Technical Service Bulletin

57 - Remotes sporadically not recognized

91 12 69 2031664/1 November 12, 2012.

Model(s)	Year	VIN Range	Vehicle-Specific Equipment
A7	2012	All	Not Applicable

Figure 1. Antenna locations.

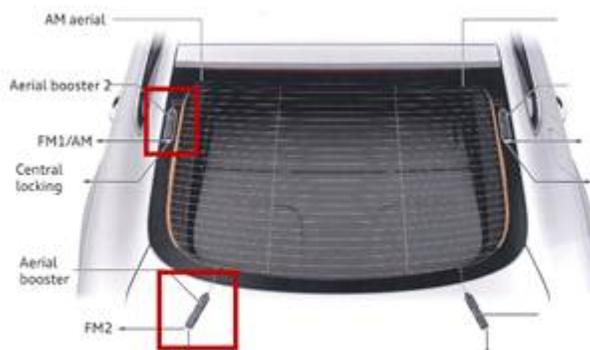
1. Remove the rear hatch covers to access both antenna amplifiers on the driver's side of the liftgate (Figure 1.).

2. Verify both part numbers are correct for the vehicle:
 - Aerial Booster 2 (upper): **4G8 035 225**
 - Aerial Booster (lower): **4G8 035 225 A**
3. If either part number is incorrect for the vehicle, replace the incorrect part.
